# Report of the Joint Review Panel

Lower Churchill Hydroelectric Generation Project  
Nalcor Energy  
Newfoundland and Labrador

Joint Review Panel established by Canada's Minister of the Environment,  
the Minister of Environment and Conservation for Newfoundland and Labrador,  
and the Minister for Intergovernmental Affairs for Newfoundland and Labrador

**Figure 4. Muskrat Falls net financial benefit to Province** (Source: Nalcor)

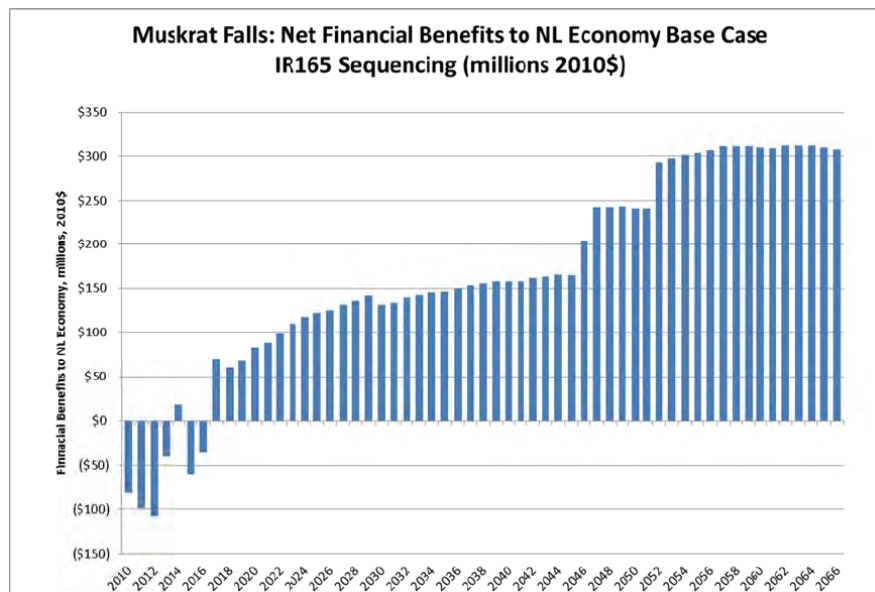
For Muskrat Falls, questions have been raised regarding returns from the portion of energy to be exported through Nova Scotia to New England and other Maritime Provinces. One participant indicated that his analysis suggests that, in the early years at least (10-20 years), the returns from those export markets would not recover costs.

The Panel notes that the main driver for the Muskrat Falls projected cash flow provided to the Panel comes from Nalcor's projected Island domestic rates that continue to escalate by two percent per annum even after Project debt payout. There are also questions about the regulatory treatment of Muskrat Falls by the provincial Government and the Public Utilities Board. It is not clear how much of the overall Muskrat Falls cost would be permitted to be passed on to the Newfoundland rate payer and what the implications are for the ability of Muskrat Falls to generate a long-term revenue stream for the Province. Further, Nalcor indicated at the hearing, that in its analysis, Muskrat Falls includes a high equity content (41 percent) and that the shareholder might forgo dividends so that not much of a revenue stream is expected from Muskrat Falls for distribution.

The Panel recommends that, if the Project is approved, before making the sanction decision for each of Muskrat Falls and Gull Island, the Government of Newfoundland and Labrador undertake a separate and formal review of the projected cash flow of the Project component being considered for sanctioning (either Muskrat Falls or Gull Island) to confirm whether that component would in fact provide significant long-term financial returns to Government for the benefit of the people of the Province. Such financial returns must be over and above revenues required to cover operating costs, expenditures for monitoring, mitigation and adaptive management, and financial obligations to Innu Nation. The Panel further recommends that the Government of Newfoundland and Labrador base these reviews on information on energy sales, costs and market returns that have been updated at the time of sanction decision, and make the results of the reviews public at that time. The financial reviews should also take into account the results of the independent alternatives assessment recommended in Recommendation 4.2.

**Figure 6. Cost thermal versus Lower Churchill power** (Source: Nalcor)

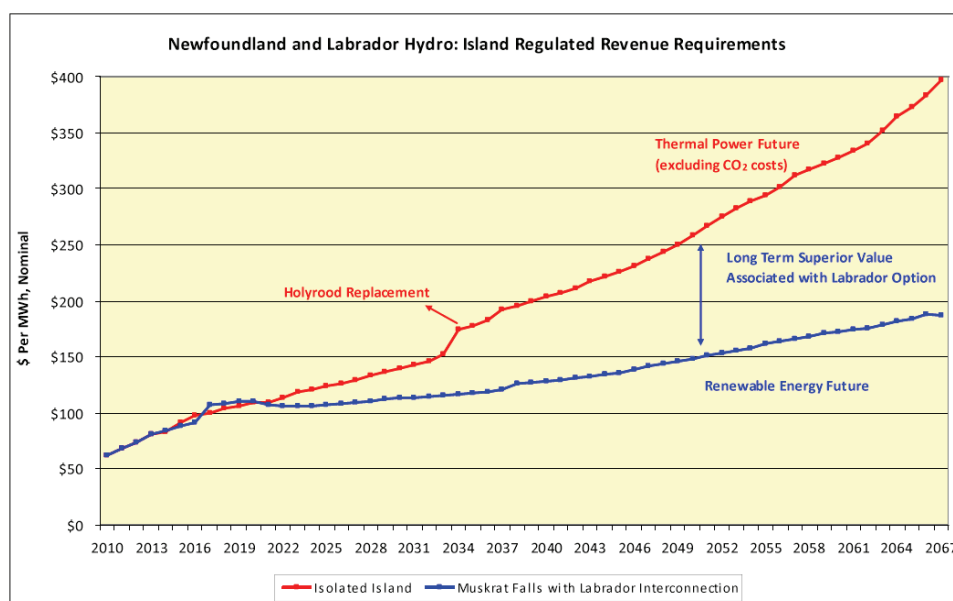
no cost for greenhouse gas emissions and no restrictions on extending the life of the Holyrood plant to the 2035 timeframe, both of which would enhance the economic competitiveness of the Project.
